CITY OF ALBUQUERQUE

**Re: Clean Machine Car Wash
6016 Central Ave SE
Traffic Circulation Layout
Engineer's 11-02-16 (K18-D079)**

SITE PLAN

SHEET NO:
C101

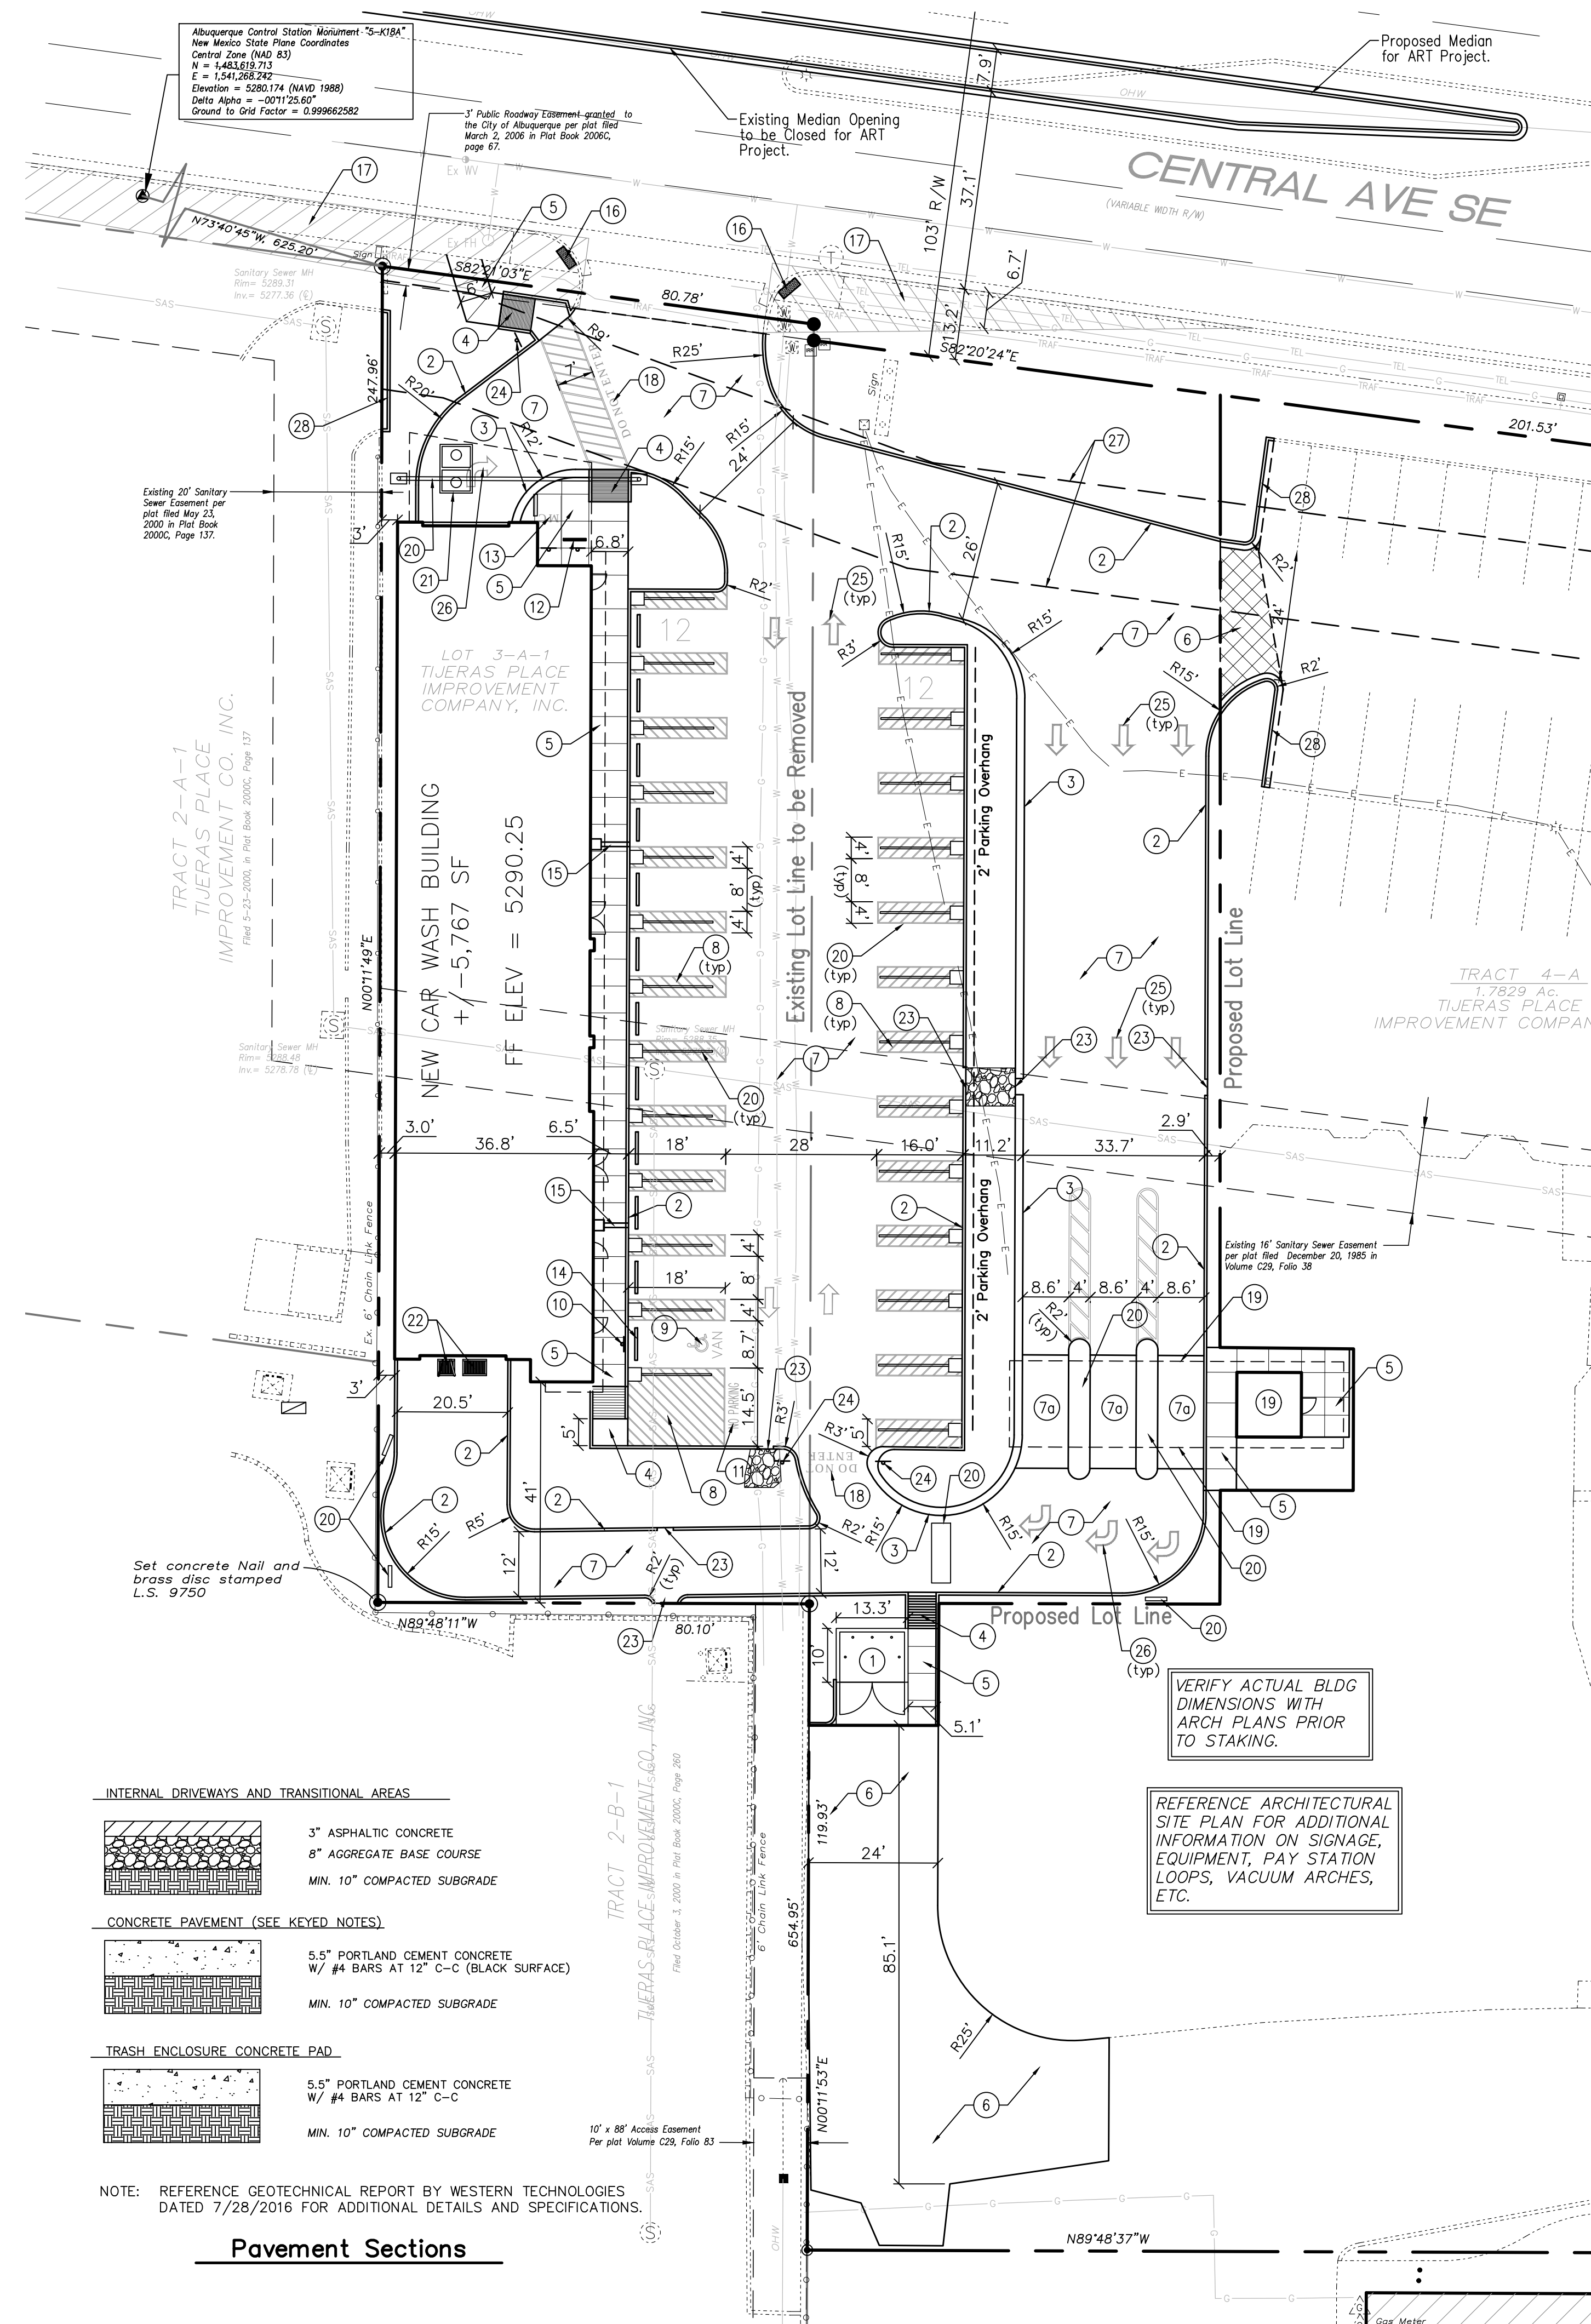
The TCL submittal received 11-02-16 is approved for Building Permit. A copy of the stamped and signed plan will be needed for each of the building permit plans. Please keep the original to be used for certification of the site for final C.O. for Transportation.

As a condition of release of final C.O. the following items must be completed prior to release of Final Certificate of Occupancy.

1. Final acceptance and approval of the replat of tract 4-A1, 4-A-2 and 8-A section 24, township 10 north, range 3 east New Mexico Principal Meridian, City of Albuquerque, Tijeras Place Improvement Company, Inc. from DRB.
